City of Santa Fe, New Mexico

memo

2025-010348-HDRB, 557 San Antonio St., Downtown and Eastside Historic District, Non-contributing, Ju Tan, agent for Clayton and Maggie Miles, owners, propose to construct a 402 sq. ft. portal addition on the main structure, a 240 sq. ft. addition with a 40 sq. ft. portal on the studio structure, and window and door replacements on the main and studio structures.

Figure 1

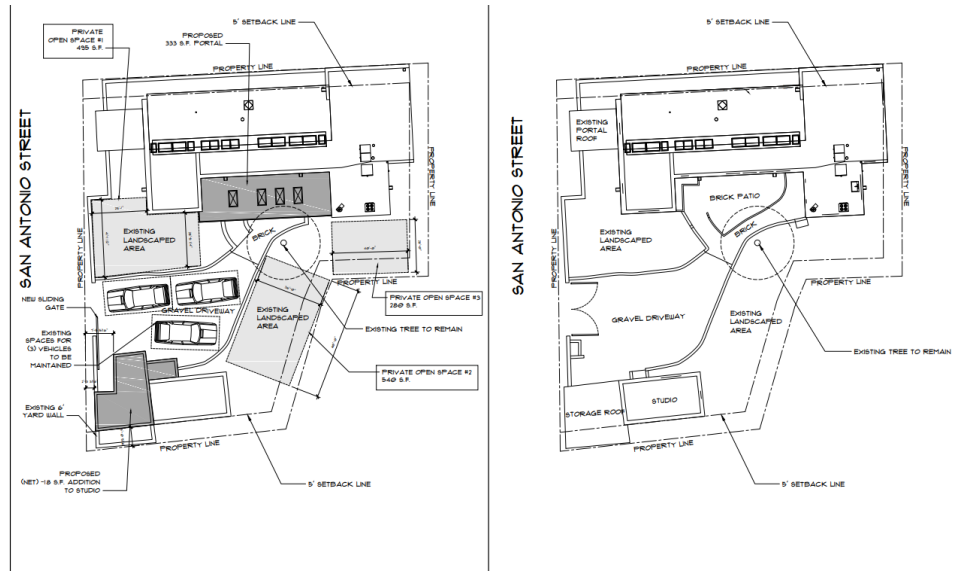
The Existing and Proposed Site Plan below demonstrates the applicant's request for the proposed work at the subject property.
